# **87C196JV/87C196JV 20 MHz SPECIFICATION UPDATE**

Release Date: January, 1997

Order Number: 272860-002

The 87C196JV/87C196JV 20 MHz may contain design defects or errors known as errata. Characterized errata that may cause the 87C196JV/87C196JV 20 MHz's behavior to deviate from published specifications are documented in this specification update.

Check for pending EPAX interrupts before exiting an EPAX ISR

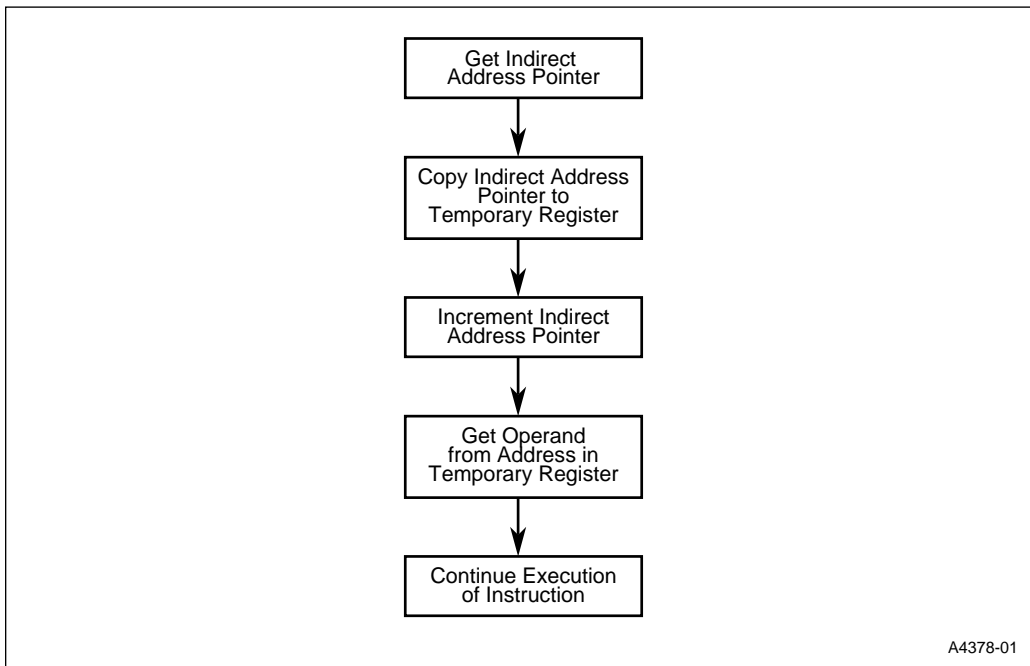
**PROBLEM:** The EPA can lock up if overruns are handled incorrectly. Overruns occur when an EPA input transitions at a rate that cannot be handled by the EPA interrupt service routine. If no overrun handling strategy is in place, and if the following three conditions exist, a situation may occur where both the capture buffer and the EPAX\_TIME register contain data, and no EPA interrupt pending bit is set:

- an input signal with a frequency high enough to cause overruns is present on an enabled EPA pin, and
- the overwrite bit is set (EPAX\_CON.0 = 1; old data is overwritten on overrun), and
- the EPAX\_TIME register is read at the exact instant that the EPA recognizes the captured edge as valid.

The input frequency at which this occurs depends on the length of the interrupt service routine as well as other factors. Unless the interrupt service routine includes a check for overruns, this situation will remain the same until the device is reset or the EPAX\_TIME register is read. The act of reading EPAX\_TIME allows the buffered time value to be moved into EPAX\_TIME. This clears the buffer and allows another event to be captured. Remember that the act of transferring the buffer contents to the EPAX\_TIME register is what actually sets the EPAX interrupt pending bit and generates the interrupt.

Another method for avoiding this situation is to check for pending EPA interrupts before exiting the EPA interrupt service routine. This is an easy way to detect overruns and additional interrupts. It can also save loop time by eliminating the latency necessary to service the pending interrupt. However, this method cannot be used with the peripheral transaction server (PTS).

**Figure 1. 16-bit System with EPROM**

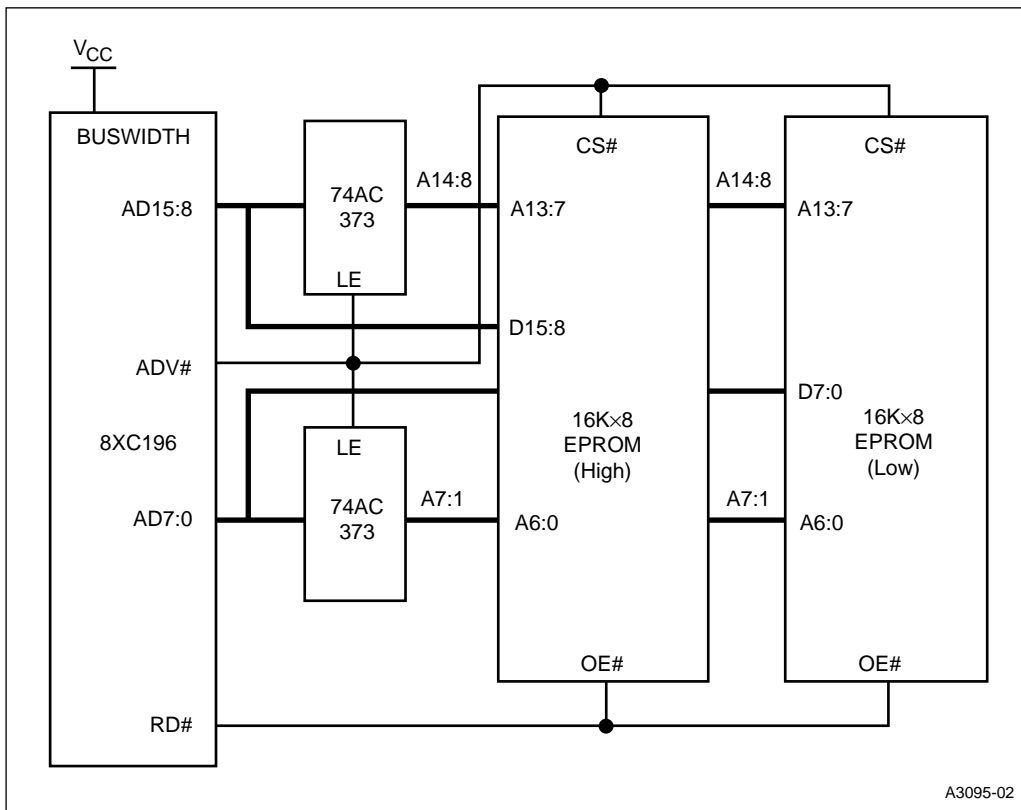
**001.** *High address inputs to the low EPROM should be A14:8 in Figure 15-18.*

**ITEM:** The next revision of the user's manual will include the following corrected graphic.
